To: T10 Technical Committee
From: Amr Wassal, PMC-Sierra (amr_wassal@pmc-sierra.com)
Date: 24 August 2006
Subject: 06-324r1 SAS-2 Modifications to the SAS Speed Negotiation

Suggested changes to chapter 6 (Phy Layer)

Figure 122 — SAS SNW-1 and SNW-2 speed negotiation windows

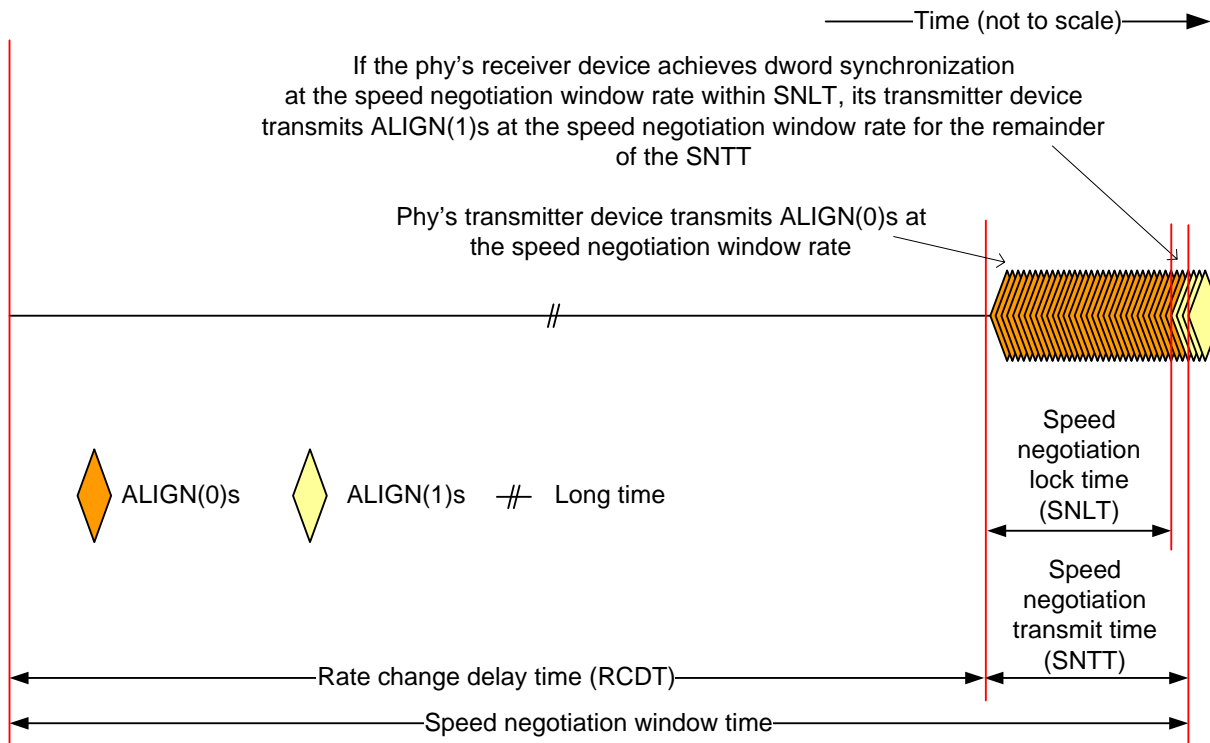
Figure 122 defines the SAS speed negotiation window for SNW-1 and SNW-2, including:

- a) speed negotiation window time;
- b) speed negotiation window rate;
- c) rate change delay time (RCDT);
- d) speed negotiation transmit time (SNTT); and
- e) speed negotiation lock time (SNLT)

Figure 123 — SAS SNW-3 speed negotiation window

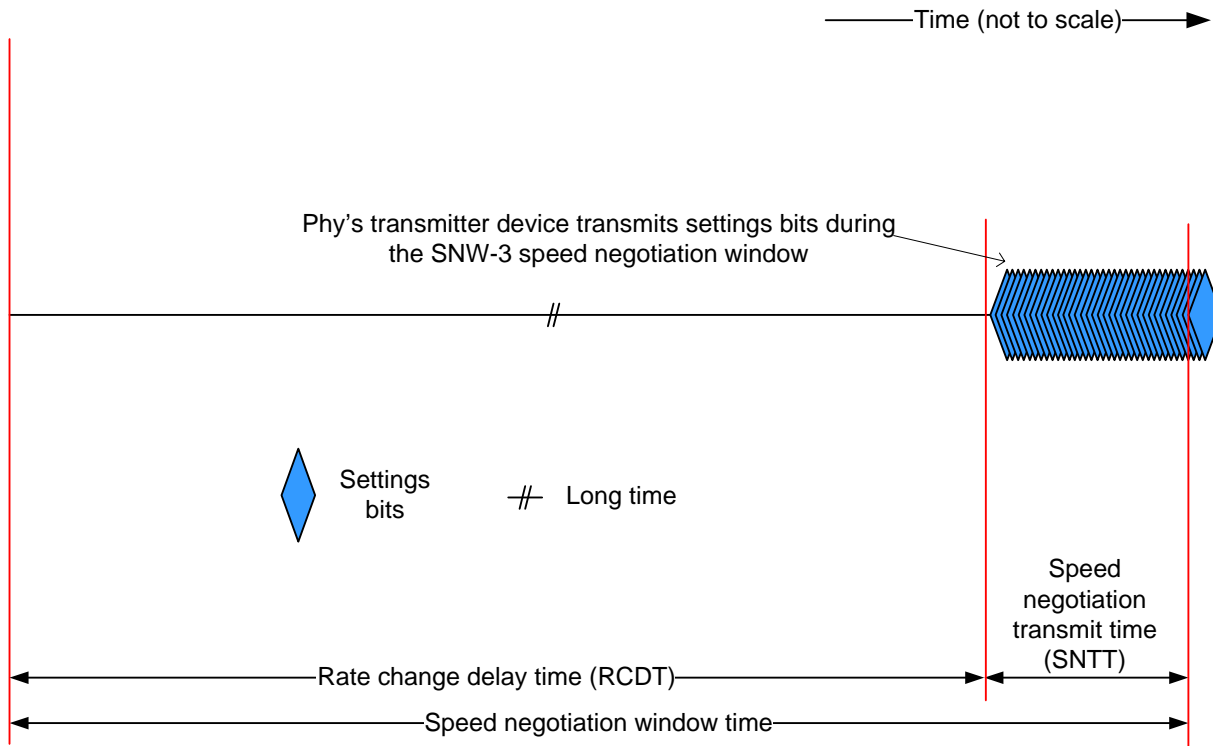
Figure 123 defines the SAS SNW-3 speed negotiation window, including:

- a) speed negotiation window time;
- b) speed negotiation window rate of 1,5 Gbps;

- c) rate change delay time (RCDT); and
- d) speed negotiation transmit time (SNTT)..

Figure 124 — SAS SNW-Final speed negotiation window

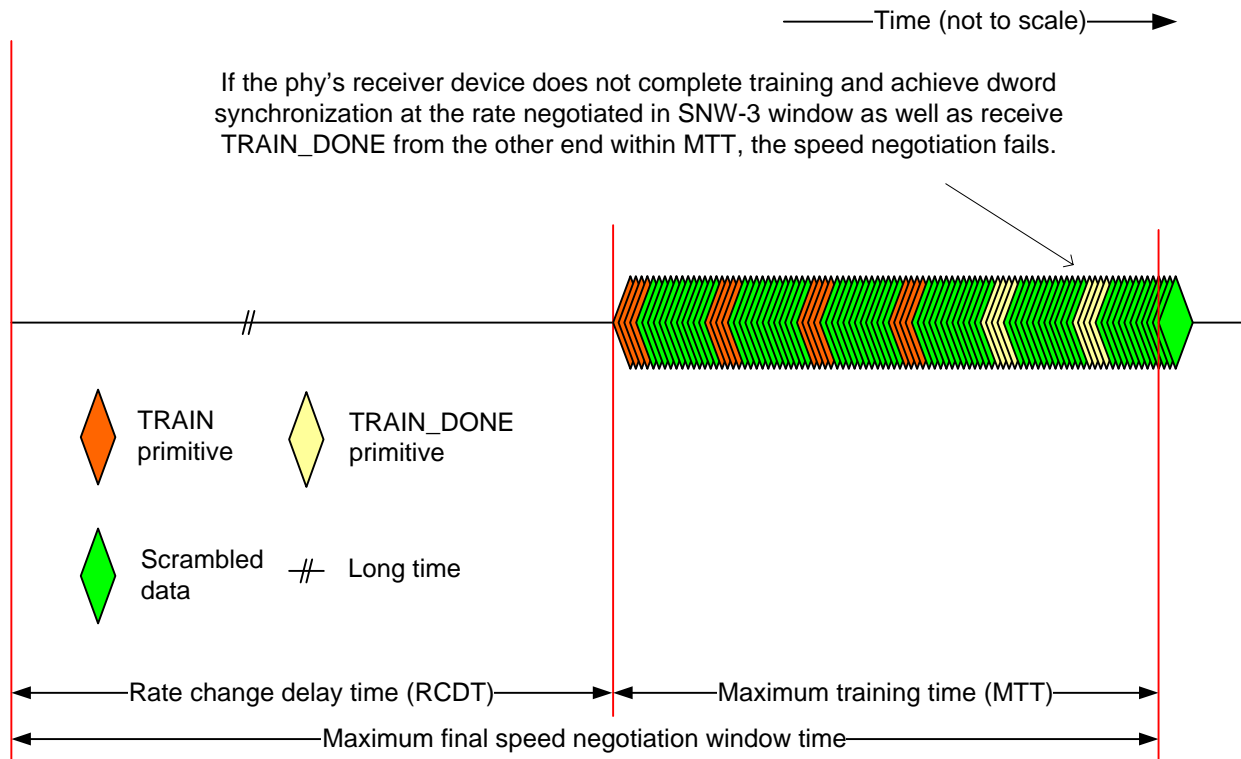
Figure 124 defines the SNW-Final speed negotiation window, including:

- a) Maximum final speed negotiation window time;
- b) rate change delay time (RCDT); and
- c) maximum training time (MTT).

The training pattern consists of repeating pattern segments. Each pattern segment shall have four TRAIN primitives followed by 160 bytes 00h that are transmitted scrambled and 8b10b encoded. When the phy's receiver device is trained, the phy shall replace the TRAIN primitives in the pattern segments with TRAIN_DONE primitives.

Figure 125 — SAS speed negotiation sequence (phy A: G1, G2, G3, phy B: G2 only)

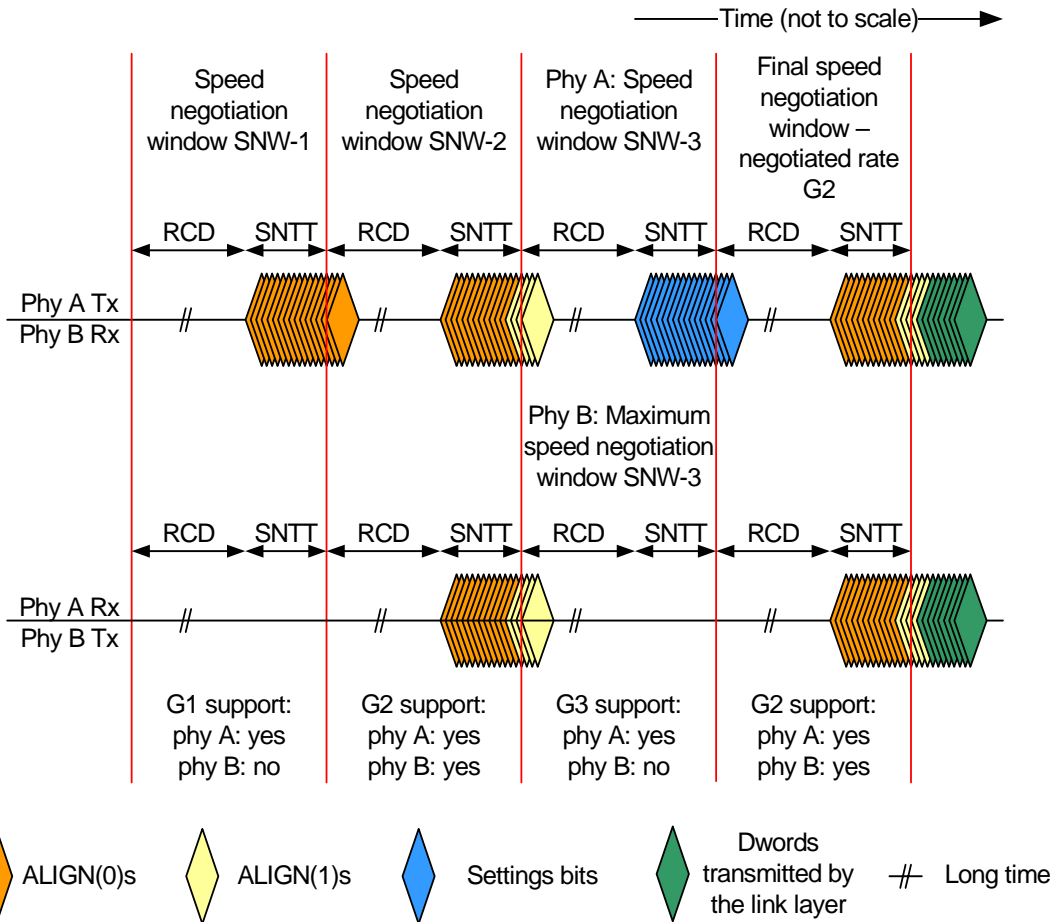
Figure 125 shows speed negotiation between a phy A that supports G1 through G3 and a phy B that only supports G2. Both phys run:

- 1) the SNW-1 speed negotiation window, supported by phy A but not by phy B;
- 2) the SNW-2 speed negotiation window, supported by both phys; and
- 3) the SNW-3 speed negotiation window, supported by phy A but not by phy B.

Phy A reaches its limit because it has run a speed negotiation window that does not detect a valid physical link rate (i.e., SNW-3) after having detected a valid physical link rate in a previous speed negotiation window (i.e., G2 in SNW-2). Phy B reaches its limit because it has reached the speed negotiation window corresponding to

its highest support physical link rate plus one (i.e., SNW-3). Both phys select G2 for the SNW-Final speed negotiation window to establish the negotiated physical link rate.

Figure 126 — SAS speed negotiation sequence - phy reset problem

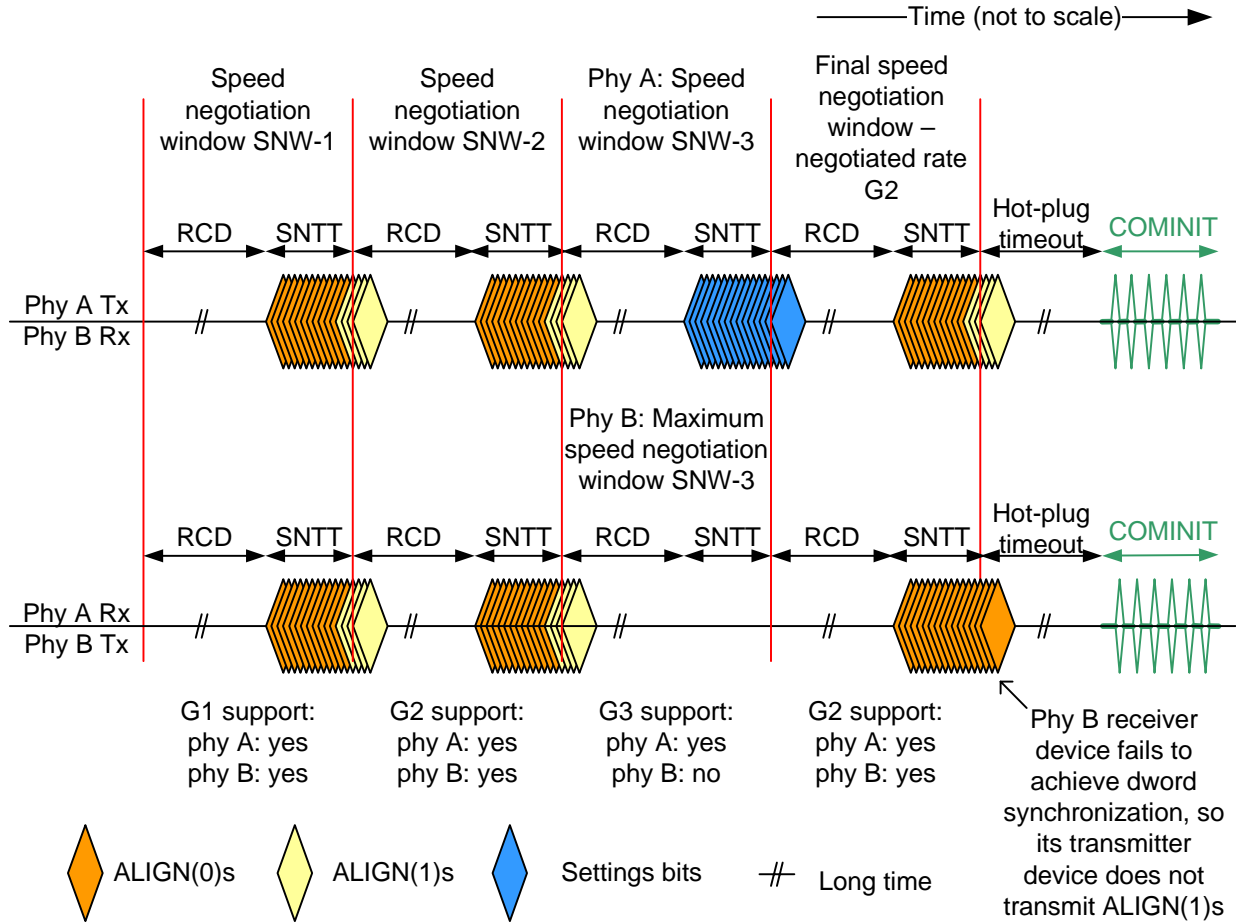
Figure 126 shows a speed negotiation sequence where phy B does not achieve dword synchronization during the final speed negotiation window. If this occurs, the handshake is not complete and the phy reset sequence is retried.

Figure 127 — SAS speed negotiation sequence (phy A: G1, G2, G3 or higher, phy B: G1, G2, G3 or higher)

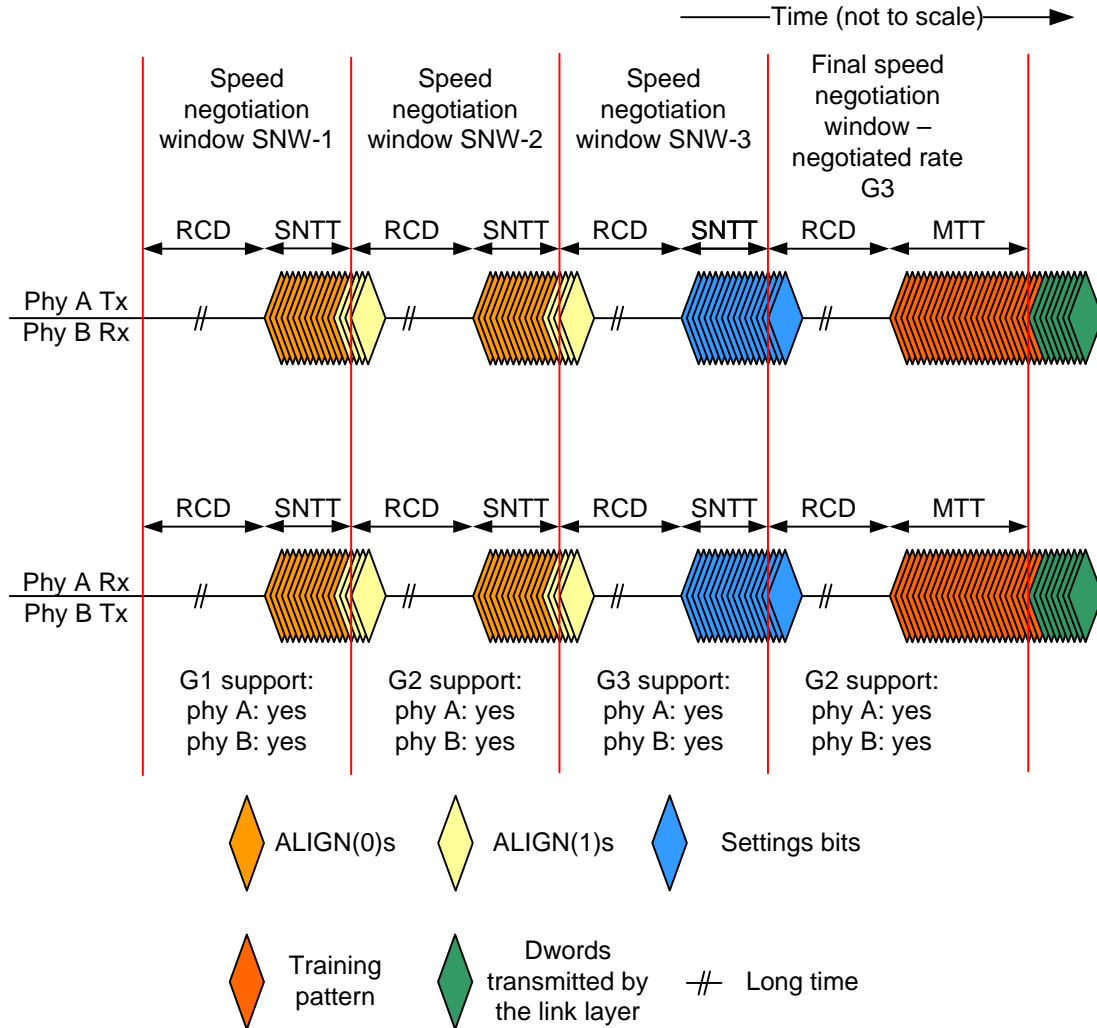
Figure 127 show speed negotiation between a phy A and a phy B that both support G3 rate or higher. Both phys run:

- 1) the SNW-1 speed negotiation window, supported by both phys;
- 2) the SNW-2 speed negotiation window, supported by both phys; and
- 3) the SNW-3 speed negotiation window, supported by both phys where the settings bits are exchanged and the highest common rate supported by both phys is negotiated; and

4) the SNW-Final speed negotiation window, supported by both phys where training is done.

Figure 128 — SAS speed negotiation sequence - SNW-3 (maximum SNW) phy reset problem

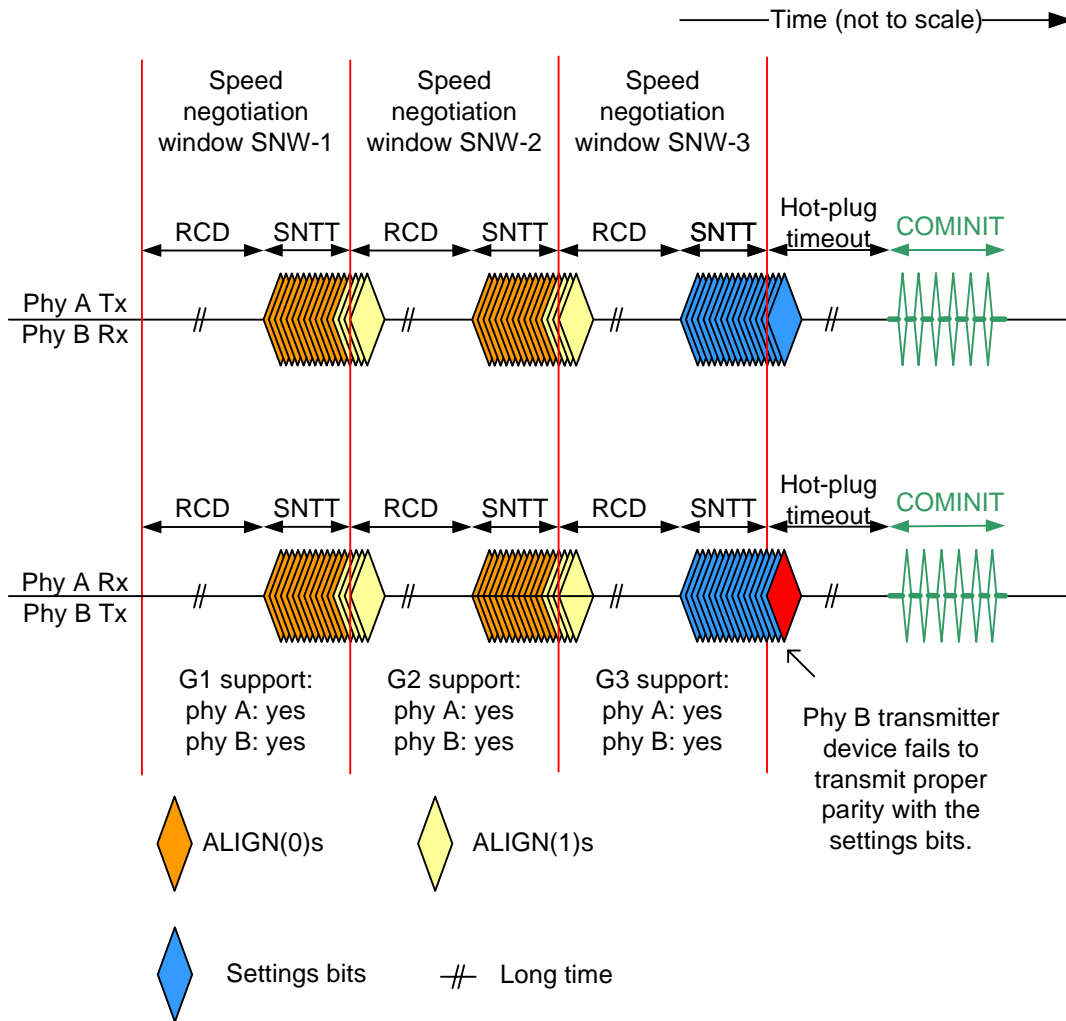
- 1) the phys do not exchange the settings bits properly (e.g., due to a parity error) in SNW-3 window (see Figure 128); or

Figure 129 — SAS speed negotiation sequence - training (SNW-Final) phy reset problem

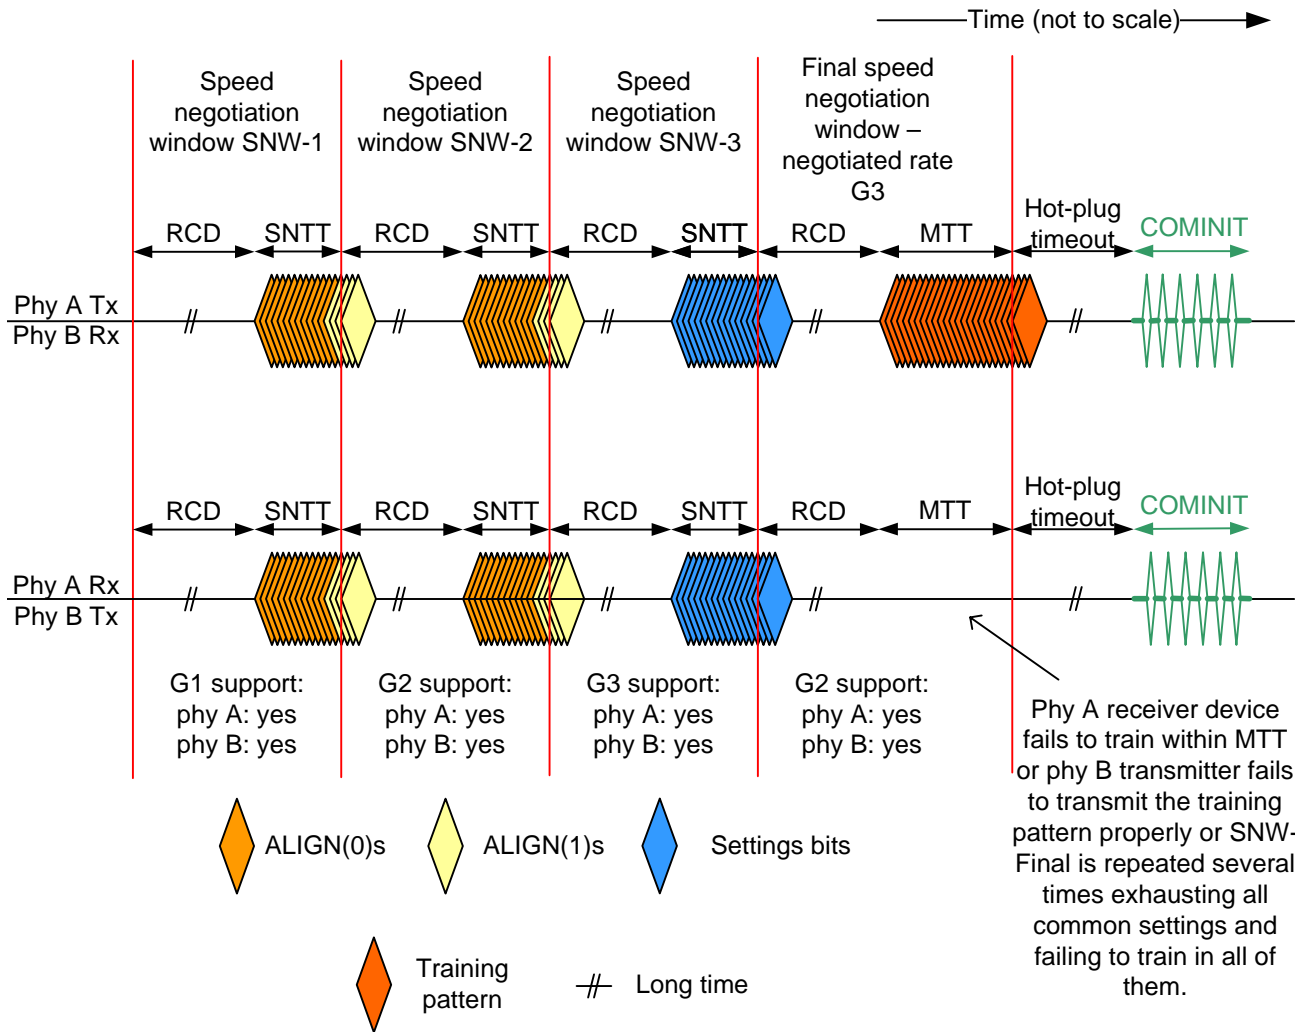
- 2) either phy does not complete training within the MTT interval of several training windows exhausting all common settings exchanged in SNW-3 (see Figure 129)..

Figure 131 — SP (phy layer) state machine - SAS speed negotiation states

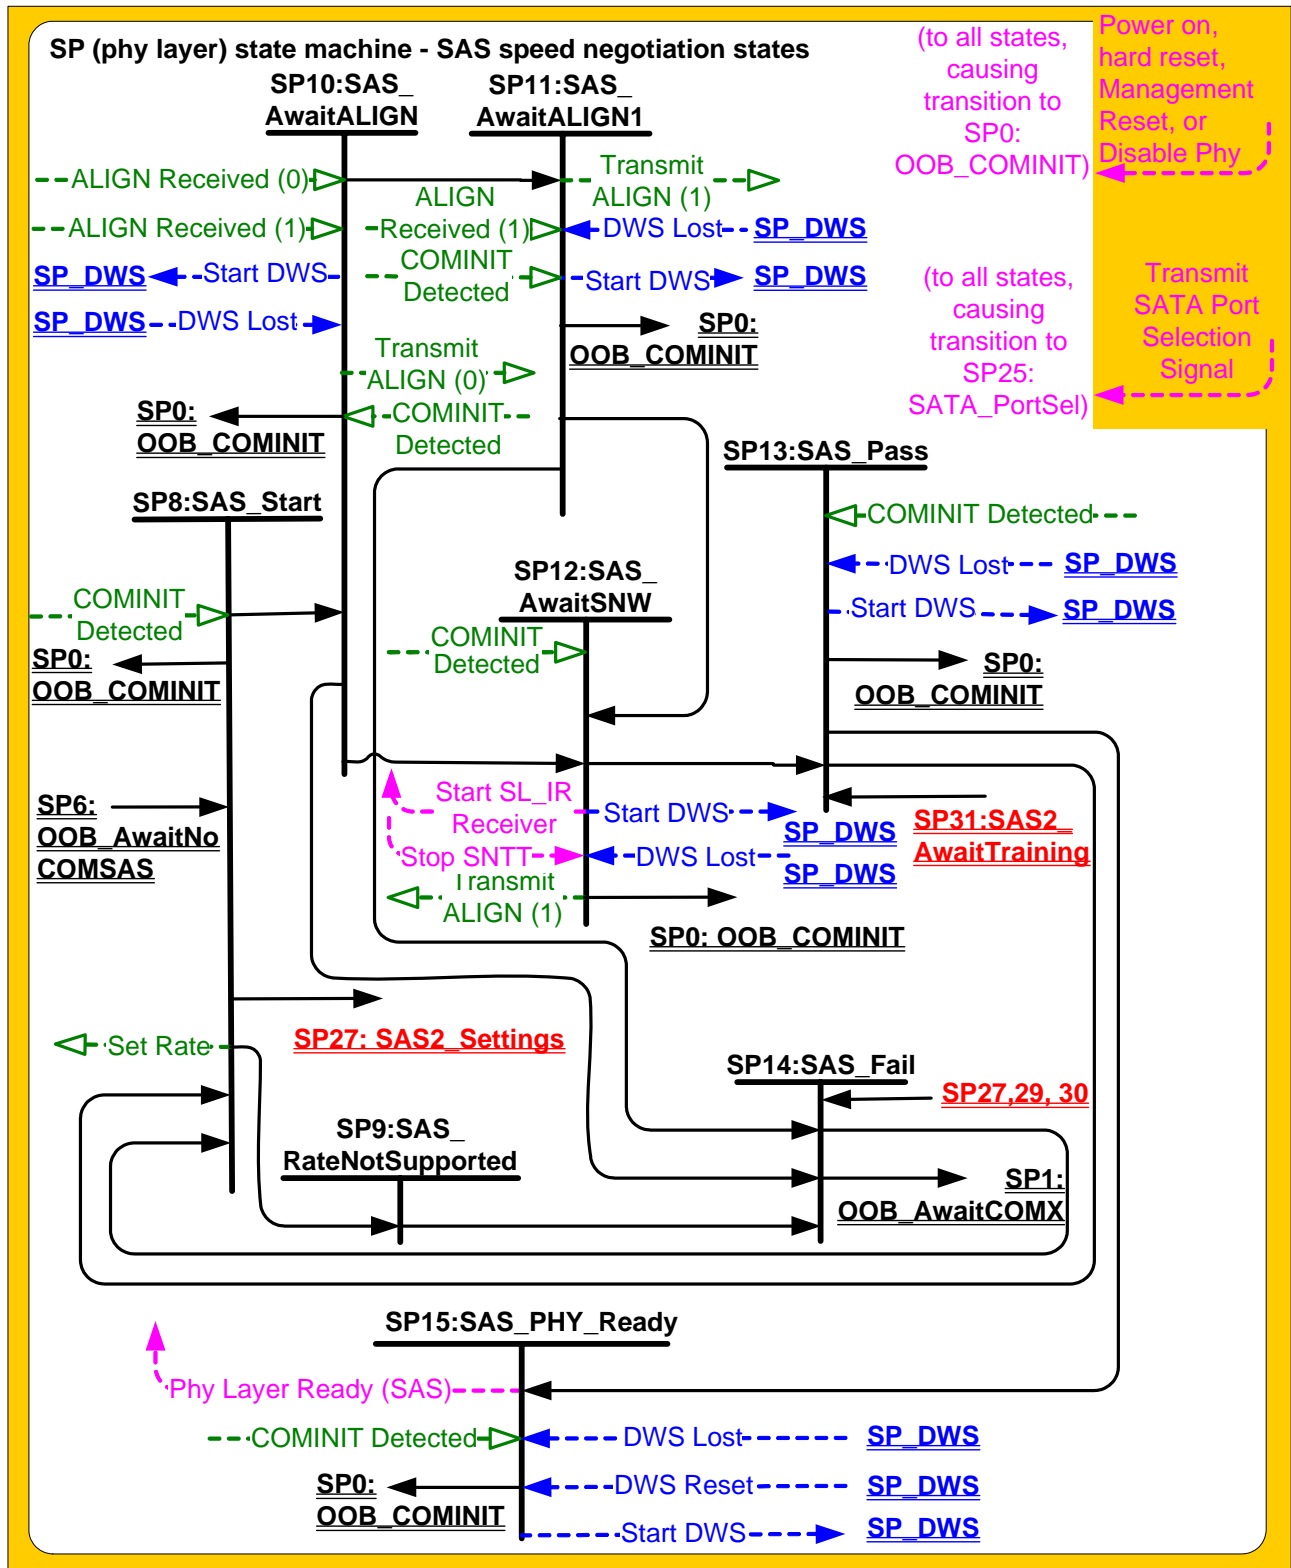
| Figure 131 shows the SAS speed negotiation states, in which the phy has detected that it is attached to a SAS phy or expander phy rather than a SATA phy, and performs the SAS speed negotiation sequence. These states are indicated by state names with a prefix of SAS.
